**Statement of Compliance
Access for People with a Disability**

**Proposed Seniors
Development**

3 Central Rd Avalon Beaches

Report Type: Statement of Compliance - BCA Access Provisions
Development: 3 Central Rd Avalon Beaches

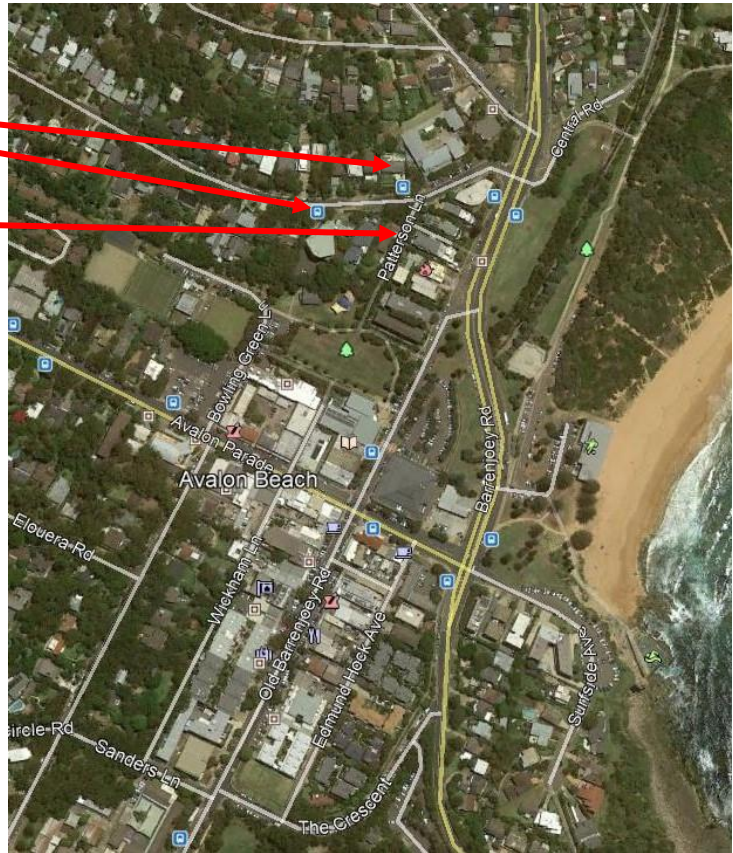
Bus stops are located within 100m of the site, travelling in either direction, with the service providing access to Avalon (Route 192) as indicated on the aerial photo above. There are also bus stops located in Barrenjoey Rd, still within 400m which also provide access to other routes but the path accessing these bus stops does not meet the gradient requirements.

Based on our investigation using a Bosch Inclinometer, the gradients of the path to the bus stops is an average travel gradient no more than 1:14. The gradient is at its maximum directly leading to the southern bus stop at 1:14 for a length of 15m but for most of the travel it is essentially flat.
